Amendments to Part B of the “Rules for the Classification of Pleasure Yachts”

RFS/007/AMN/05
Effective from 1/2/2023

Figure 1

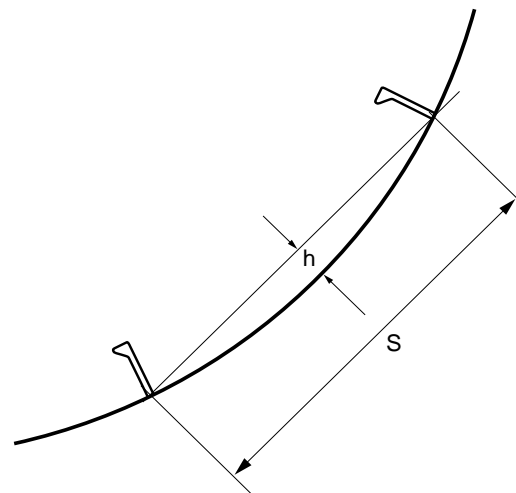
3.1.1 (1/2/2023)

k_2 : curvature correction factor given by $1-(h/s)$ to be taken not less than 0,7 where h is the distance, in mm, measured perpendicularly from the chord s to the highest point of the arc of plating between the two supports (see Fig 1).
